# Service Manual

COMPACT PLAIN PAPER FACSIMILE

**KX-F1010 SERIES**  
**KX-F1016TW**  
**KX-F1810 SERIES**

**Subject : Parts Change**

Fig. 1

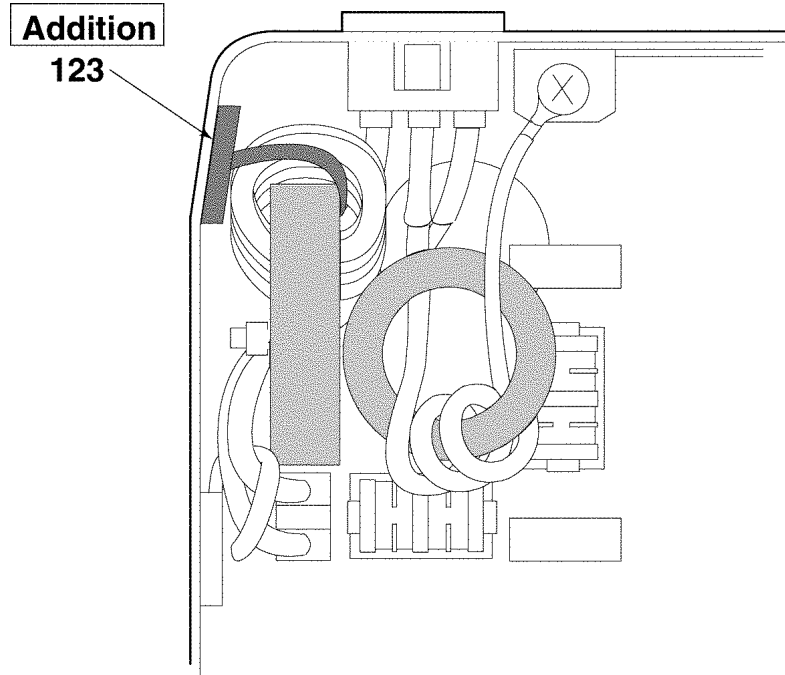
1. Improve performance	<b>Remarks:</b> <b>*a: For delivery.</b> <b>*b: To prevent the AC Leads from getting caught between the Digital Board and Bottom Frame.</b> <b>*c: To chnage the factory mode.</b>

Ref No.	Part No.		Part Name & Descriptions	Pcs	Remarks	Notes		Time of change (Suffix)
	Original Part No.	New Part No.						
CABINET AND ELECTRICAL PARTS								
105	PQJP03S07Z	PFJP03S04Z	AC INLET	1	*a	8	V	
123	-----	PQHR136Z	CLAMPER See Fig.1 (KX-F1010RS, KX-F1016TW only)	1	*b	5		
DIGITAL BOARD PARTS								
IC2	PFWIF1010ML	PFWIF1010ML1	IC (ROM) (KX-F1010ML only)	1	*c	1	X	ROM Ver. E111MA→E111MB
IC2	PFWIF1010SA	PFWIF1010SA1	IC (ROM) (KX-F1010SA only)	1	*c	1	X	ROM Ver. E111PA→E111PB
IC2	PFWIF1010TK	PFWIF1010TK1	IC (ROM) (KX-F1010TK only)	1	*c	1	X	ROM Ver. E111DB→E111DC
IC2	PFWIF1010BX	PFWIF1010BX1	IC (ROM) (KX-F1010BX only)	1	*c	1	X	ROM Ver. E111BD→E111BE
IC2	PFWIF1016TW	PFWIF1016TW1	IC (ROM) (KX-F1016TW only)	1	*c	1	X	ROM Ver. E111TA→E111TB
IC2	PFWIF1810NL	PFWIF1810NL1	IC (ROM) (KX-F1810NL only)	1	*c	1	X	ROM Ver. E111KN→E111KP
IC2	PFWIF1810SP1	PFWIF1810SP2	IC (ROM) (KX-F1810SP only)	1	*c	1	X	ROM Ver. E111LB→E111LC
